NASSCO'S REPLY COMMENTS ON THE
SAN DIEGO REGIONAL WATER
QUALITY CONTROL BOARD CLEANUP TEAM'S
SEPTEMBER 15, 2010 TENTATIVE CLEANUP AND
ABATEMENT ORDER NO. R9-2011-0001,
DRAFT TECHNICAL REPORT, AND
SHIPYARD ADMINISTRATIVE RECORD

Re: NASSCO's Reply Comments on the Tentative Cleanup and Abatement Order No. R9-2011-0001 and Draft Technical Report

Figure 1:

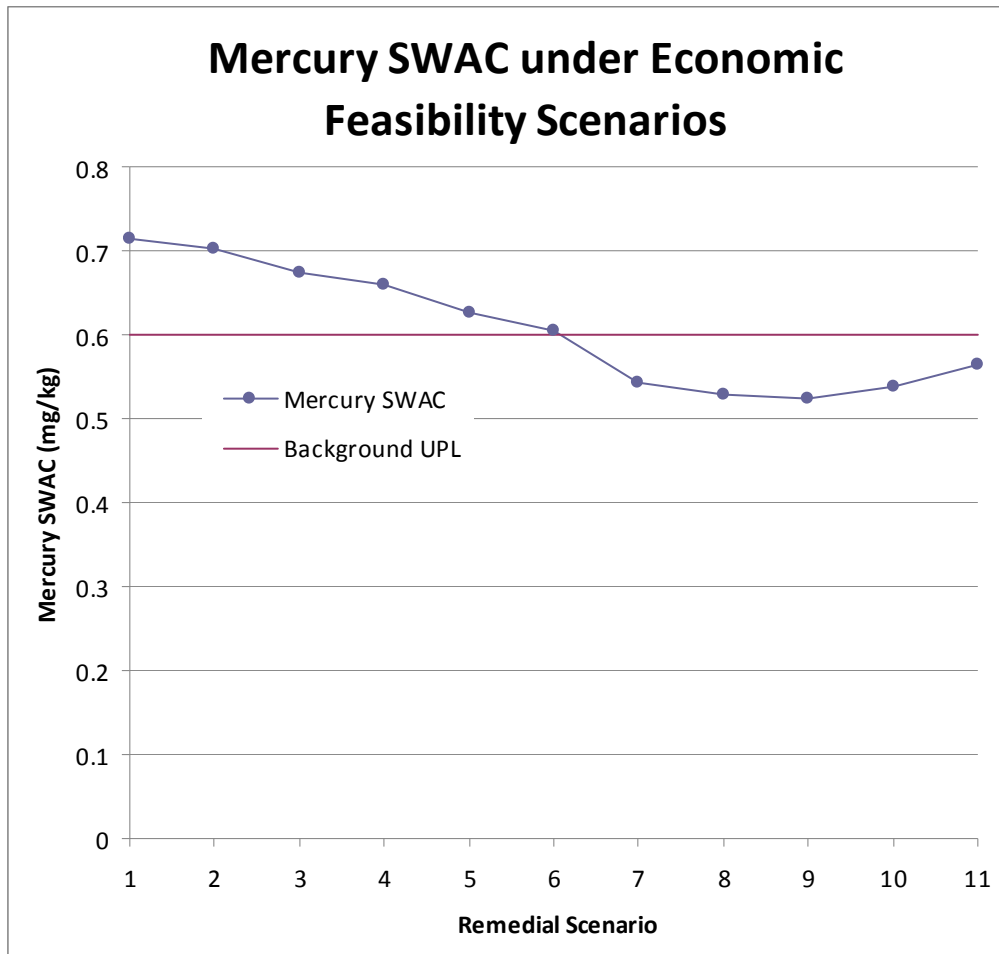
EHC/Coastkeeper Comment No. 27: The Order sets the “Remedial Goals” as compliance with “Trigger Concentrations” above the Alternative Cleanup Levels - and in some cases ABOVE existing pollutant levels.

indistinguishable from the target post-remedial SWAC, given the number of samples that make up the SWAC. Attachment A, Exponent Critique, at 4.

EHC/Coastkeeper's assertion that the cleanup can be completed without removing any mercury from the Site is misleading, and takes the post-remedial trigger out of the context in which it is to be used. While the trigger concentration for mercury (0.78 mg/kg) is higher than the pre-remedial Sitewide SWAC (0.72 mg/kg), it is much lower than the concentration in the remedial footprint. As noted above (see response to Comment No. 14), the mercury SWAC at the Site is not highly elevated (1.2x background), and average mercury levels do not presently pose a significant risk to any receptor. The primary cleanup goal with respect to mercury is to remove isolated areas of elevated mercury, not to lower the Sitewide SWAC. Elevated mercury is limited to a few areas, and these areas have been targeted by the DTR recommended cleanup. Eight of the 10 polygons with the highest surface concentrations of mercury are included in the proposed footprint (see DTR Table 33-4), with concentrations ranging from 4.5 to 1.2 mg/kg. The post-remedial monitoring program will ensure that these target areas are remediated, and verify that the target Sitewide mercury SWAC (which is only slightly lower than the pre-remedial SWAC) is achieved within reasonable statistical precision. Id.

Figure 1 Metals ratios (cadmium and zinc) for sediments from Chollas Creek and Site.

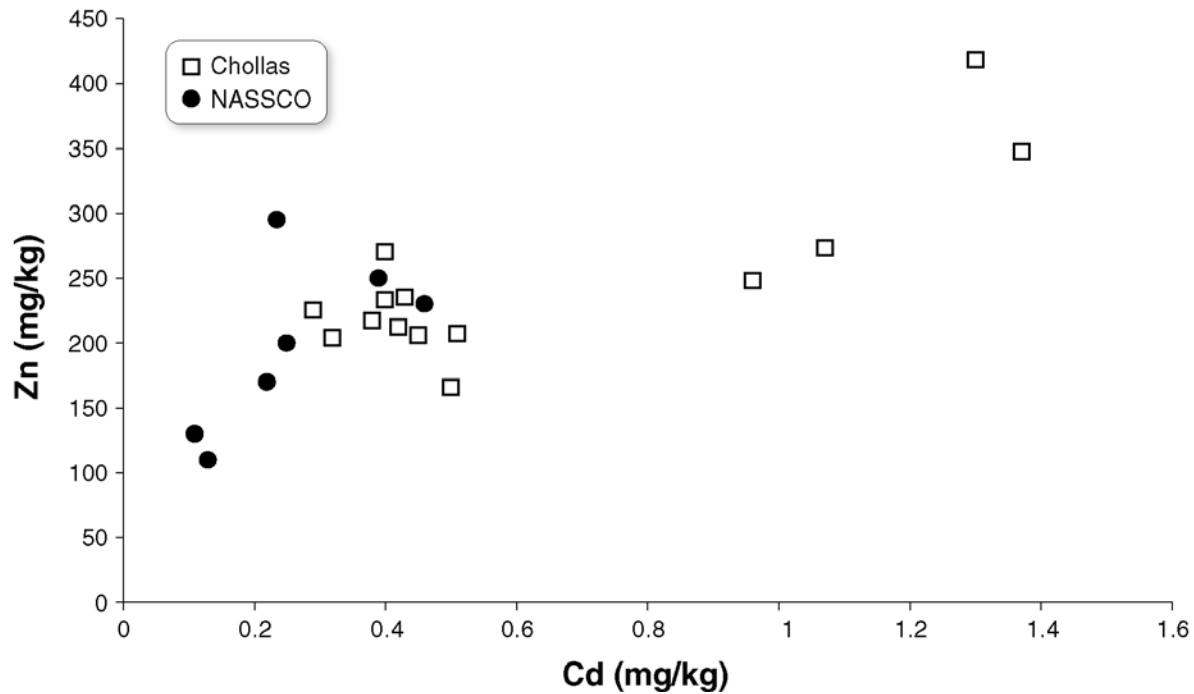
The Navy presents Figure 12 showing cadmium concentrations plotted against zinc concentrations, in other words the concentration ratios, for sediments from the Chollas Creek area and the Site. They argue that the ratios should be similar if the Chollas Creek sediments are a significant source of contaminants to the Site. The Navy's Figure 12 indeed shows that the plotted points for the Chollas Creek sediment and the Site sediment fall on different trend lines.

Chollas Creek sediment samples¹³ are from the top 2 cm, taken in July/Aug 2001 (SCCWRP and SPAWAR 2005). Site stations¹⁴ data are from Exponent collected in 2001 and 2002. Figure 1 is a plot of cadmium and zinc concentrations similar to the Navy's Figure 12. However, these samples of surface sediment collected within a year of each other do not show a clear difference. The data points for Chollas and Site (NASSCO) samples show significant overlap in cadmium – zinc ratios, which indicates that Chollas Creek is indeed a source of COCs to the Site.

Figure 2. Metals ratios (copper and zinc) for sediments from Chollas Creek and Site.

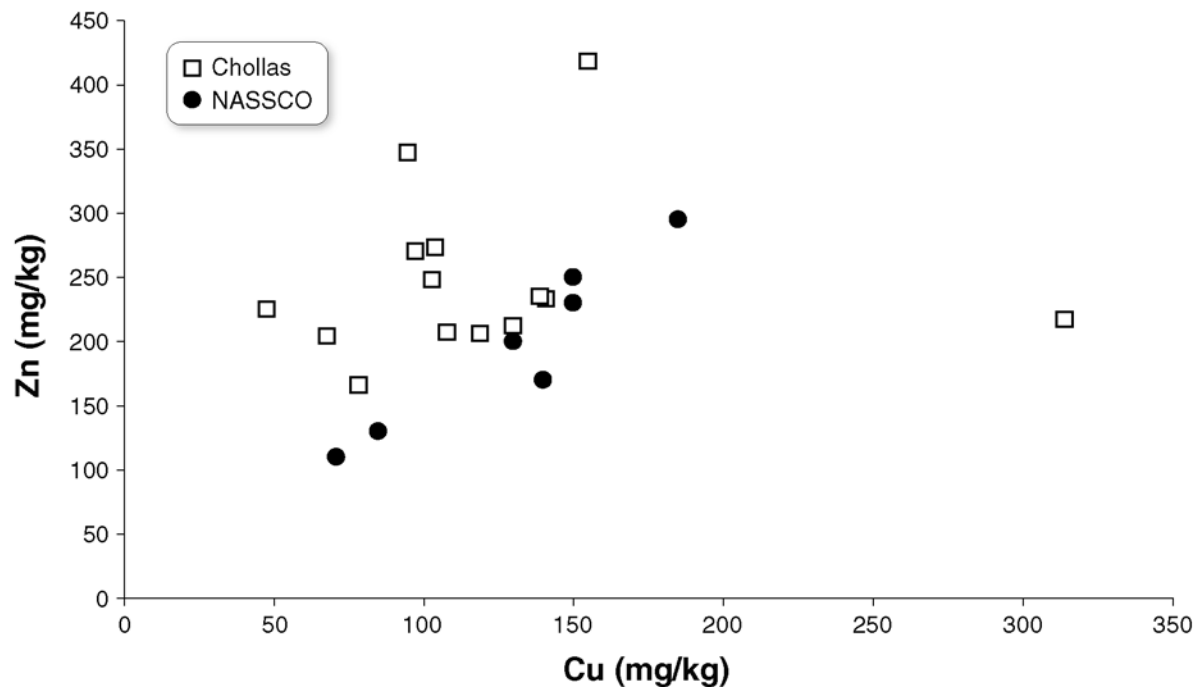
The Navy also notes that concentrations of copper and zinc are higher in Site sediments than in the Chollas Creek sediments. It states that this suggests that leachate from Navy vessels in the Chollas Creek region is not a significant source of copper and zinc in the Site sediments. This conclusion is misleading because even though the concentrations are higher in Site sediments this should not detract from the fact that there is a gradient of copper and zinc from the Chollas Creek sediments in the direction of the Site. Sources in the Chollas Creek area may not be the largest sources of copper and zinc to the Site sediment, but they are still a significant source.

A more relevant comparison is a comparison of copper and zinc ratios because they are both significant COCs in the Chollas Creek and the Site area, whereas cadmium is not as significant a COC. The ratios of copper and zinc are shown in Figure 2. In this case, copper – zinc ratios for Chollas Creek show a wide spread distribution. There is also significant overlap with the copper – zinc ratios for Site sediments which indicate, contrary to the Navy’s argument, that Chollas Creek sediments are a source of copper and zinc to the Site.

Figure 2. Shown is Figure A-4 from SCCWRP (2005) depicting the distribution of clay a Chollas Creek.

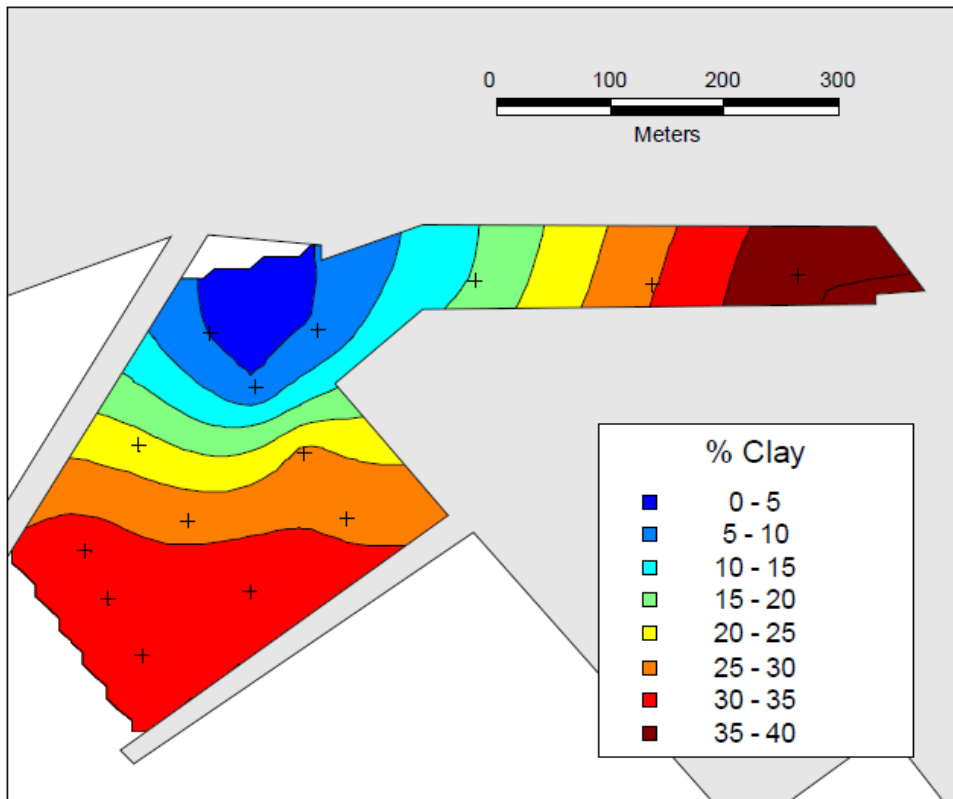
Another critical problem with Dr. Poon's declaration is that he relies on the model's portrayal of the deposition of clay and silt size particles based on his characterization of inflow from Chollas Creek and ignores sediment data which indicates where clay and silt size particles derived from Chollas Creek actually do settle out. For example, Figures A-3 through A-5 of SCWRP, 2005, Sediment Assessment Study for the Mouths of Chollas and Paleta Creek, San Diego Phase I Report (SCCWRP and U.S. Navy, 2005): Appendix A – F, clearly shows deposition of not only silt, but also clay even within the mouth of Chollas Creek, as shown in Figure 2 below. For this reason, Dr. Poon's statement that fine-grained particles settle out in the mouth of Chollas Creek and that clay-size particle are dispersed throughout the Bay with very minimal deposition in the SY should not be considered.
